Subject: Westinghouse Owners Group
Transmittal of Responses to NRC Comments from the February 24, 1999 Core Damage Assessment Meeting (MUHP-1302)

Attachment A
Westinghouse Owners Group Response to NRC Comments/Questions
on WCAP-14696, Core Damage Assessment Guidance

Typical Fuel Rod Clad Failure Temperatures

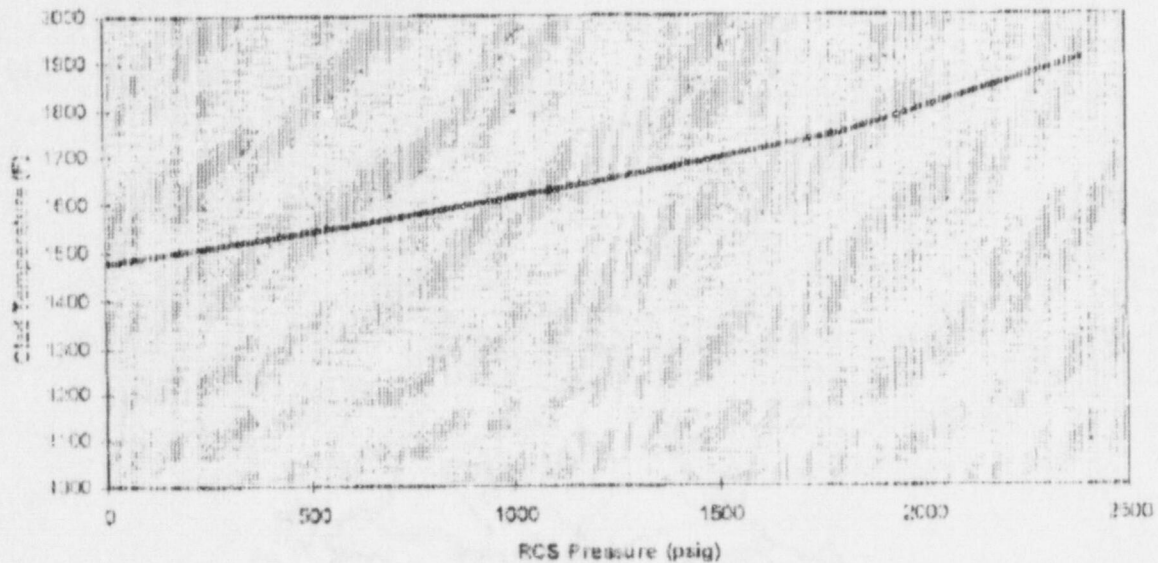
NRC Comment P37, paragraph 3:

Describe what evidence exists to demonstrate that the RCS pressure/temperature relationship provides a reliable basis for judging whether clad rupture will occur. Justify that the codes do not contain conservatism that may tend to over-predict clad failure. Should address this through a validation activity.

The results of a number of MAAP analyses for a typical 4 loop Westinghouse PWR, at different reactor coolant system pressures, were used to develop a generic profile of clad burst vs. RCS pressure. This is reproduced in Figure 1.

This figure shows rod burst for a large LOCA at a clad temperature of about 1475°F. This corresponds to a core exit thermocouple indication of just over 1200°F (Page 37 of the WCAP-14696). At a 2200 psig reactor coolant system pressure, the corresponding clad temperature at which failure would be predicted to occur is about 1800°F. This corresponds to a 1600°F core exit thermocouple indication.

Taking into account variations in fuel rod strength, clad temperature vs. core exit indication, burnup, time at temperature for plastic strain to progress, etc., the values of 1200°F and 1600°F were chosen to represent high and low RCS pressure conditions at the time of clad overheating to the damage point.

A review of core damage sequences from PRA studies shows that most sequences either remain above a value of about 1600 psig or fall to at least the steam generator secondary side pressure relief setpoint (e.g., 1050 psig) before fuel rod overheating occurs. For those events above this value (1600 psig), natural circulation in the reactor coolant system and reflux cooling from the steam generators is generally occurring which slows the core heatup rate and results in the a "typical heatup rate, regardless of RCS pressure. In addition, the core exit thermocouples would be expected to more closely track the cladding temperatures (i.e., less than 2000°F). Thus, a value of 1600 psig for the RCS pressure to distinguish between high and low pressure core damage events is appropriate.
